802.3dj D2.0

Comment Resolution

Common Track

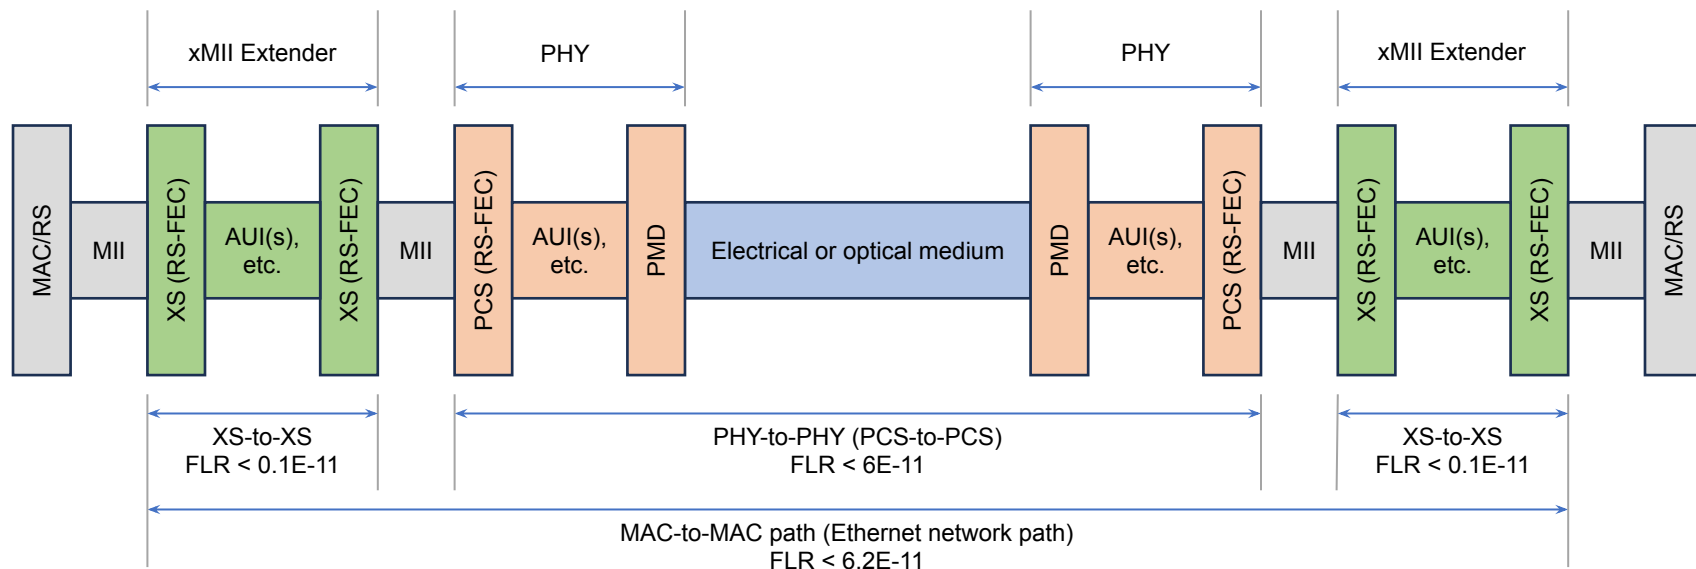
Diagrams showing the various paths or domains described in 174A.3 through 174A.7 would be very helpful to the reader of the annex.

Add a diagrams illustrating the paths described in 174A.3 through 174A.7.

A figure will make this much more clear

Add a figure to show the link in 174A.5, 174A.6 and 174A.7

In the subclause title "Error ratio allocation for an Ethernet network path", the term "network path" is a bit vague. Network path may mean a multi-hop network path (e.g. End Host to Switch to End host). Should search for a more descriptive term to use instead of "network path". Since the error allocation is from the PLS service interface of one RS to the PLS service interface of the other RS, suggest using "RS-to-RS" ? or MAC-to-MAC ? This is similar to PHY-to-PHY, PCS-to-FEC, etc. terminology used in other sections of this annex.

Replace "network path" in the subclause title with "RS-to-RS".

PROPOSED ACCEPT.

PROPOSED ACCEPT IN PRINCIPLE.
Resolve using the response to comment #292.

PROPOSED ACCEPT IN PRINCIPLE.
Ultimate the path is from MAC to MAC. Also, RS can easily be misinterpreted as meaning RS-FEC.
Change "network path" to MAC-to-MAC path.

Proposed generalized figure for MAC-to-MAC path

Relevant to 174A.3, 174A.4, 174A.5 (excluding 800GBASE-ER1/ER1-20)

Option #2: Allow either AUIs in the PHY or Extender, but not both

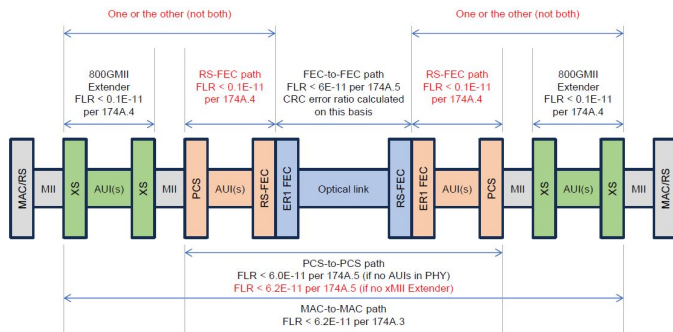
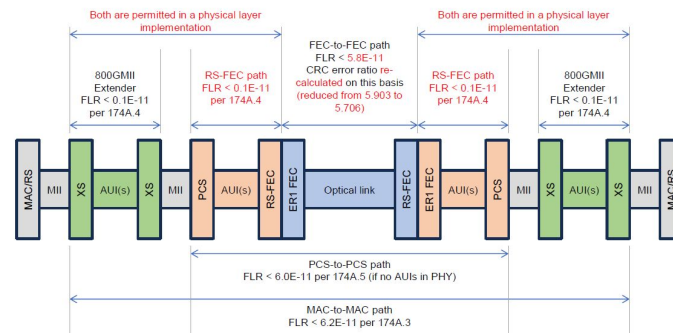
For 800GBASE-ER1/ER1-20...

Option #2 (above) was adopted in Draft 1.5.

- Requires different figure

D2.0 comment #xxx proposes to adopt option # (right)

- Can use same figure as previous slide, if adopted

Proposed figure for optical PHY types

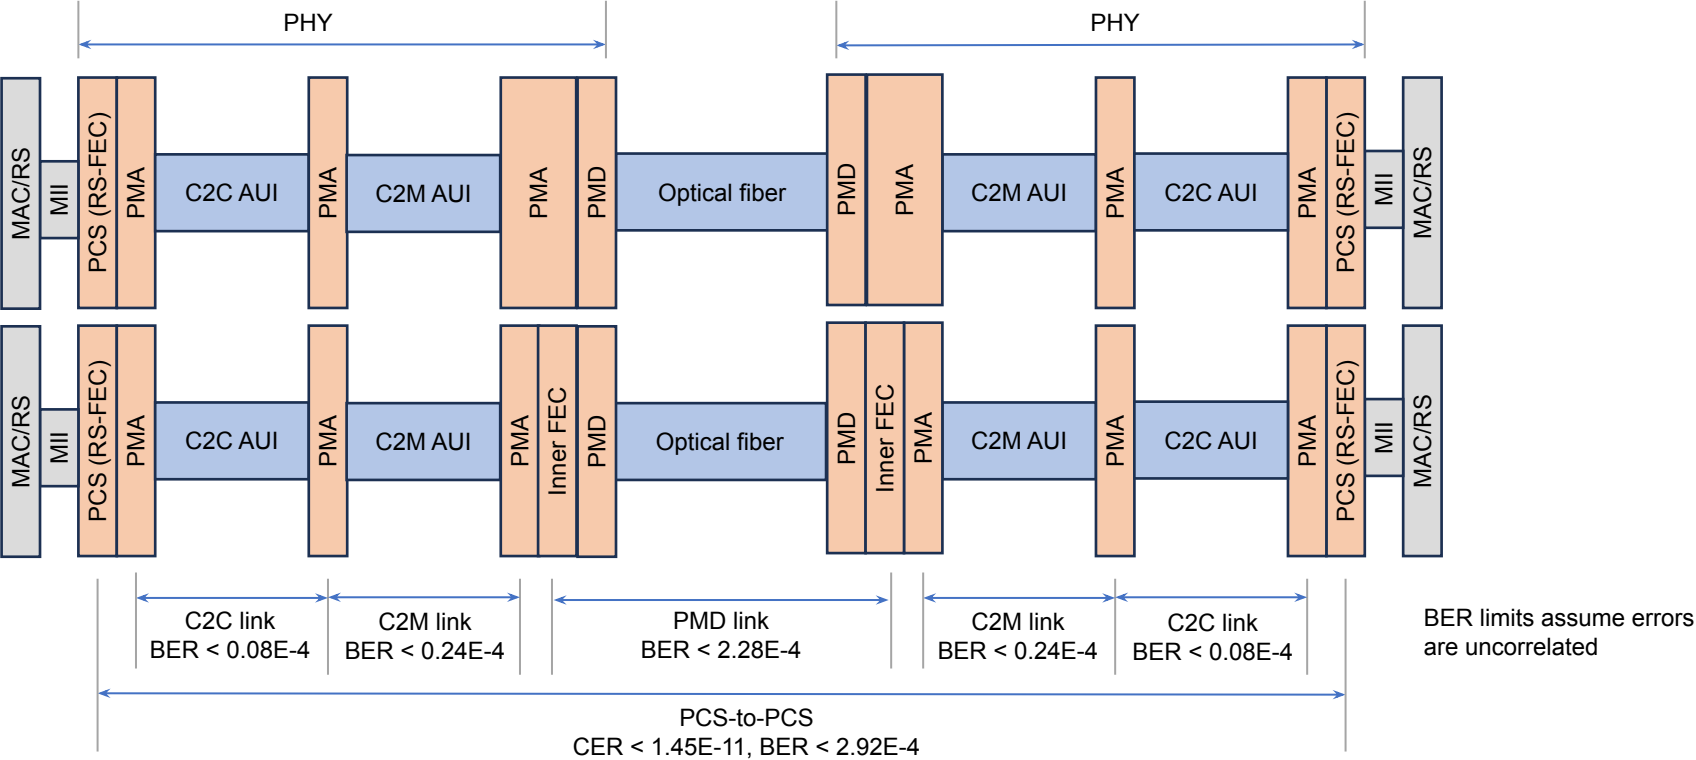
Cl 174A	SC 174A.6	P 678	L 28	# 585
Nicholl, Gary		Cisco Systems		
Comment Type	TR	Comment Status	D	(Common) FLR allocation
FLR allocation for 800GBASE-ER1/ER1-20.				
During the March plenary the consensus was to adopt option# 2 of https://www.ieee802.org/3/dj/public/25_03/brown_3dj_04a_2503.pdf , for the FLR allocation for 800GBASE-ER1/ER1-20.				
Also, see the final response to comment #16 in https://www.ieee802.org/3/dj/comments/D1p4/8023dj_D1p4_comments_final_clause.pdf .				
An implication of this decision is that 800GBASE-ER1/ER1-20 PHYs are different from other 802.3dj PHYs, in that you are only allowed to have AUIs in the PHY or Extender, but not both (see slide 18 of brown_3dj_04a_2503). For other 802.3dj PHYs you are allowed to have AUIs in both the PHY and the Extender.				
This means it is possible to have a host design that contains two AUIs (one in an Extender and one in the PHY) that would not support an 800GBASE-ER1/ER1-20 PHY, but would support all other 802.3dj PHYs.

I don't think that an 800GBASE-ER1/ER1-20 PHY should be treated as a special case.				
I propose changing the FLR allocation for the 800GBASE-ER1/ER1-20 PHY to be consistent with all other 802.3dj PHYs, such that there are no restriction on which hosts an 800GBASE-ER1/ER1-20 PHY can be deployed in.				
This is essentially option #3 in brown_3dj_04a_2503, where the FLR of a 800GBASE-ER1/ER1-20 PHY, with or without an AUI, is defined as 6 x 10 ⁻¹¹ (consistent with all other 802.3dj PHYs). This in turn means reducing the FLR for the ER1-to-ER1 FEC link from 6 x 10 ⁻¹¹ to 5.8 x 10 ⁻¹¹ .				
<i>Suggested Remedy</i>				
Change the FLR allocation for 800GBASE-ER1/ER1-20 to implement option #3 in https://www.ieee802.org/3/dj/public/25_03/brown_3dj_04a_2503.pdf .				
Make the necessary changes in clauses 187 and 174A.				
A supporting presentation will be provided.				
<i>Proposed Response</i>		<i>Response Status</i> W

Comment #585 proposes to change the FLR budgeting for 800GBASE-LR1. The appropriate diagram can be used once that decision is made. Shown here for reference.

PROPOSED REJECT.				
The comment proposes to change a decision made by the CRG as detailed in the comment. However, the comment makes a good case and a proposal is forthcoming.				
Pending task force review of the supporting contribution.

Figure 178B-8—Training control state diagram

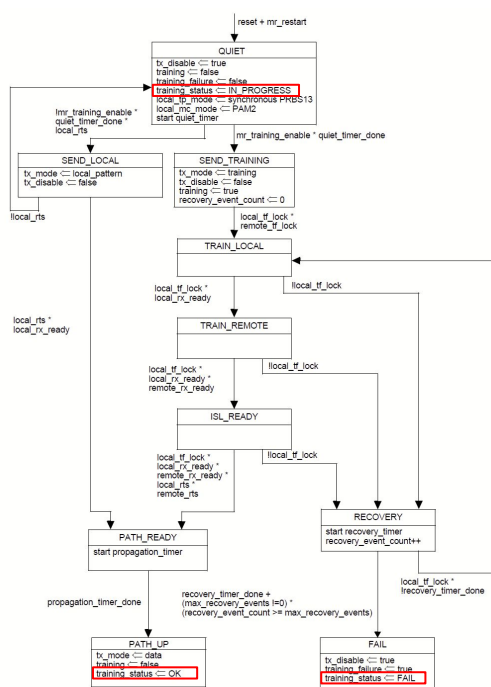
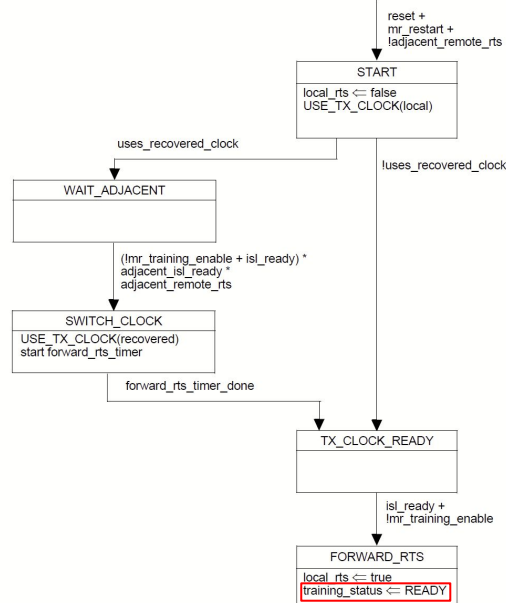
Training status can not be both a AUI component variable and a per-lane training variable.
Local_rts is an equivalent status to it and is mapped to a MDIO register bit.

Move the definition of training_status to 178B.14.3.1
Remove the enumeration of "READY" from its definition.
Delete training_status <= READY from Figure 178B-7

The variable training_status is used by the 'Training control state diagram' in subclause 178B.14.3.5 'State diagram figures' but is not defined in the associated subclause 178B.14.3.1 'Variables'.

In addition, it appears that the training_status is a per-interface variable based on the definition found in 178B.14.2.1 'Variables', yet it appears to be driven by both the per-interface 'RTS update state diagram' (Figure 178B-7) and the per-lane 'Training control state diagram' (Figure 178B-8). I'm not sure how this would operate.

As an example, if the Training control state diagram on one lane in an interface enters the FAIL state, it would set training_status for the interface to FAIL. If, however, the Training control state diagram on another lane in the same interface enters the PATH_UP state immediately afterwards, training_status for the interface would then be set to OK. This doesn't seem to be correct.

Provide a definition for the training_status variable used in Figure 178B-8 'Training control state diagram' in its associated subclause 178B.14.3.1 'Variables'. In addition, clarify the operation of training_status regarding it being driven by both the per-interface 'RTS update state diagram' (Figure 178B-7) and the per-lane 'Training control state diagram'.

training_status is defined as a per-interface variable (in 178B.14.2.1), but it appears in both per-lane and per-interface state diagrams. Formally there needs to be more than one variable.

Note that the value READY is assigned only be the per-interface state diagram; READY is equivalent to (all lanes are IN_PROGRESS) and (local_rts is true).

PROPOSED ACCEPT IN PRINCIPLE.
training_status is used by the PMDs and AUIs (see 178.4, 179.4, 180.3, 181.3, 182.3, 183.3, 176C.6 and 176D.4) so it shall be assigned a value by ILT.
It is a per-interface variable that is assigned to all lanes of the interface.
Define a new variable in 178B.14.3.1: lane_training_status. Defined as: Enumerated variable that indicates the status of the per-lane ILT function. This variable may be assigned one of the following values: IN_PROGRESS, OK, FAIL.
Use this new variable in the per-lane state diagrams instead of training_status.
Change the definition of the variable training_status to: Enumerated variable that indicates the status of the per-interface ILT function. This variable may be assigned one of the following values: IN_PROGRESS, READY, OK, FAIL. The value READY is assigned by the RTS update state diagram (Figure 178B-8) and other values are assigned according to the lane_training_status variable (see 178B.14.3.1):

IN_PROGRESS - lane_training_status variable = IN_PROGRESS for any lane assigned to the interface
OK - lane_training_status variable = OK for all lanes assigned to the interface
FAIL - lane_training_status variable = FAIL for any lane assigned to the interface
Implement with editorial license.

PROPOSED ACCEPT IN PRINCIPLE.
Resolve using the response to comment #459.

Define a new variable in 178B.14.3.1 (Per-lane variables): lane_training_status

Enumerated variable that indicates the status of the training control state diagram. This variable may be assigned one of the following values: IN_PROGRESS, OK, FAIL.

Use this new variable in the per-lane state diagrams instead of training_status.

Option A: keep it as a state diagram variable and change its definition as follows:

Option B: delete its assignment from the per-interface state diagram (Figure 178B-8), making it a non-state-diagram variable, and use the following definition:

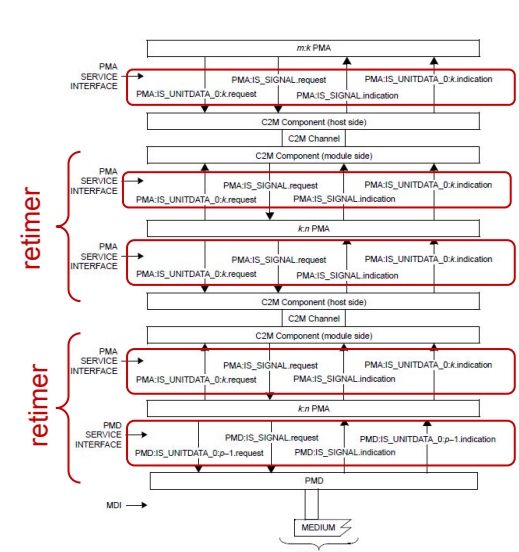
This is not very clear. I would suggest adding the definition of "adjacent service interface" in subclause 178B.3.

SuggestedRemedy
 I would suggest adding the definition of "adjacent service interface" to subclause 178B.3 and referencing a diagram, like the one on Slide 3 of "Making Sense out of ILT" (J. D'Ambrosia, M. Brown, 802.3dj Joint Ad hoc Mtg - 05 Jun 2025).

The second case in the NOTE says: "For ILT in an AUI component above a PMA, the adjacent service interface is the interface below the AUI component". That is the PMA's service interface. It may be easier to understand if it is stated.
 Also, a figure illustrating the two cases would be helpful.

SuggestedRemedy
 Change "the adjacent service interface is the interface below the AUI component" to "the adjacent service interface is the PMA service interface (below the AUI component)". Add a figure, with editorial license.

Proposed Response Response Status W
 PROPOSED ACCEPT IN PRINCIPLE.

The term "adjacent service interface" is not clearly defined.

Editorial slides will be provided to address this.

Proposed Response Response Status W
 PROPOSED ACCEPT IN PRINCIPLE.

Clarification of the term "adjacent service interface" is not clearly defined.

Editorial slides will be provided to address this.

There is only one service interface on an AUI component or PMD, so it is not necessary to qualify it with the word "adjacent".

In fact, the word adjacent is used to reference the AUI component or PMD on the other side of a retimer.

Change the note in 178B.14.2.1 to:
 NOTE — For a PMD or an AUI component below a PMA, SIGNAL_OK is received via the IS_SIGNAL.request primitive of the service interface above the PMD or AUI component. For an AUI component above a PMA, the SIGNAL_OK is received via the IS_SIGNAL.indication primitive of the service interface below the AUI component.

Change other references of "adjacent service interface" to "service interface".

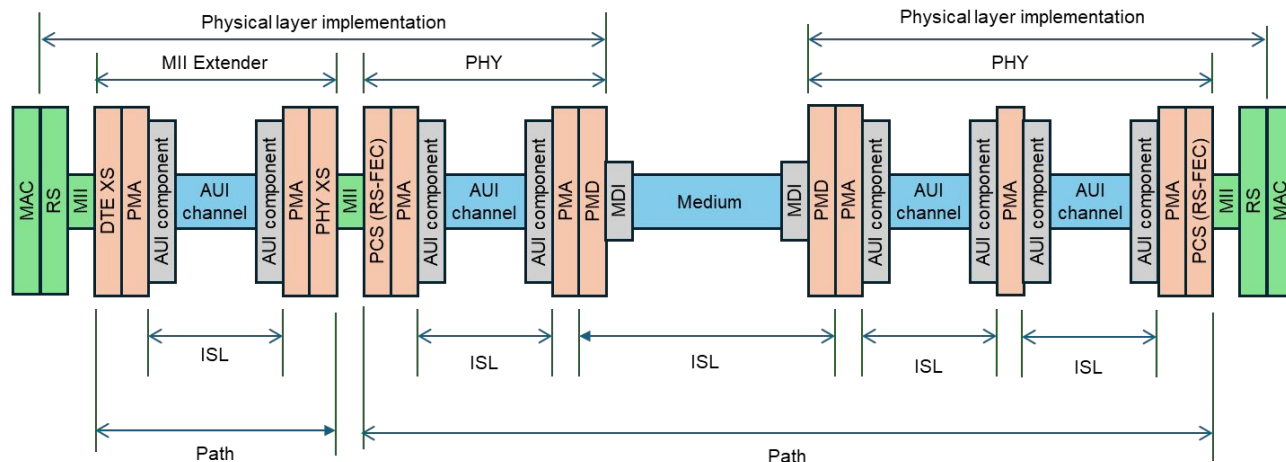
Given the introduction of inter-sublayer link training to the Ethernet world, it would be helpful if the term inter-sublayer link (ISL) was displayed graphically for the reader.

Implement figure on Page 3 of
https://www.ieee802.org/3/dj/public/adhoc/electrical/25_0605/dambrosia_3dj_elec_02_250605.pdf with editorial license

PROPOSED ACCEPT IN PRINCIPLE.

Pending review of the following presentation and CRG discussion.

However, this slide provides an figure, update since presented to the ad hoc.

The diagram captures the various entities as defined for ILT in D2.0.

This diagram is provided as a reference for discussion and as a proposed diagram to add into Annex 178B.

As shown, the diagram includes two path types: XS-to-XS in an xMII extender and PCS-to-PCS across a pair of PHYs and the medium between.

178B.5.3 Training xMII Extenders

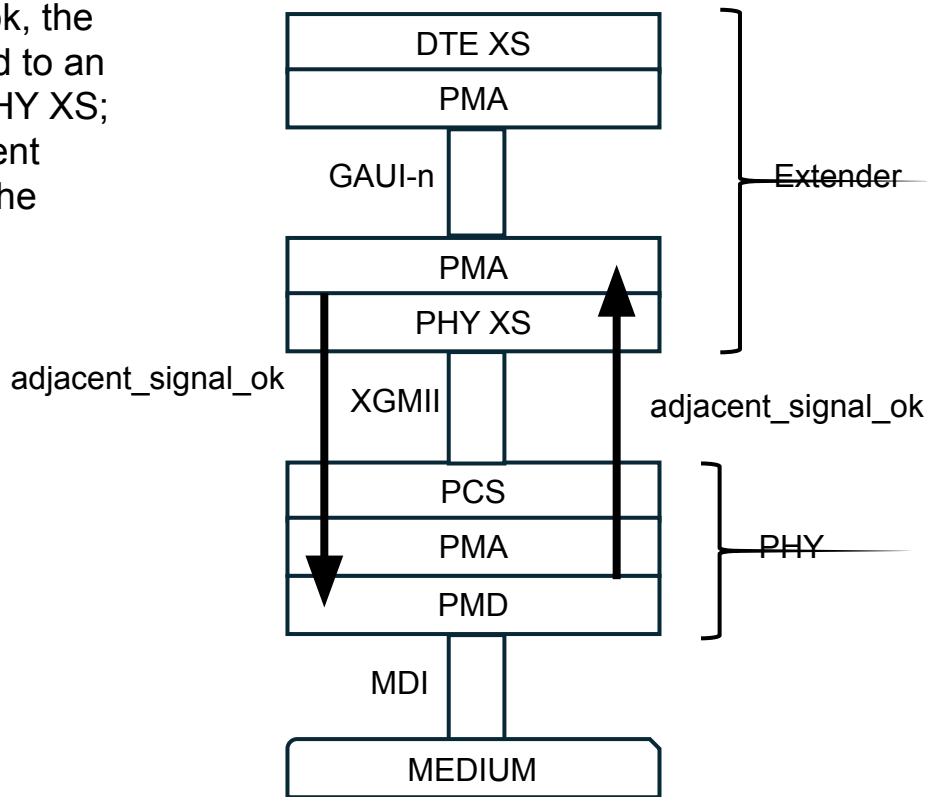
The text about training xMII extenders does not address the communication of the status variables `isl_ready` and `remote_rts` between interfaces (PMD to AUI and vice versa) when there is a PHY XS and PCS between them.

Ideally, this communication should be the same as the one defined in 178B.14.2.1 using `adjacent_signal_ok`, but the case of an extender is not covered by NOTE that describes what "adjacent" is.

Since this behavior is specific to PHYs attached to extenders, it should be specified in this subclause, preferably with a diagram.

Add a NOTE in 178B.5.3 stating that, for the purpose of `adjacent_signal_ok`, the adjacent interface of a PMD in a PHY attached to an xMII extender is the service interface of the PHY XS; and the adjacent interface of the AUI component above the PHY XS is the service interface of the PMD.

Add a figure to illustrate the communication of `adjacent_signal_ok` between the PMD and the AUI (across the PCS and PHY XS, and possibly other sublayers).

PROPOSED ACCEPT IN PRINCIPLE.

Implement suggested remedy with editorial license.

NOTE – For the purpose of adjacent_signal_ok, the adjacent interface of a PMD in a PHY attached to an xMII extender is the service interface of the PHY XS; and the adjacent interface of the AUl component above the PHY XS is the service interface of the PMD.

- Option 2

- ILT is done separately on extenders, and RTS is not communicated to the RS-to-RS link – such that extenders create separate paths
- As can be interpreted from D2.0 text

- Option 3

- Either Option 1 or Option 2 is allowed (left open for implementation)
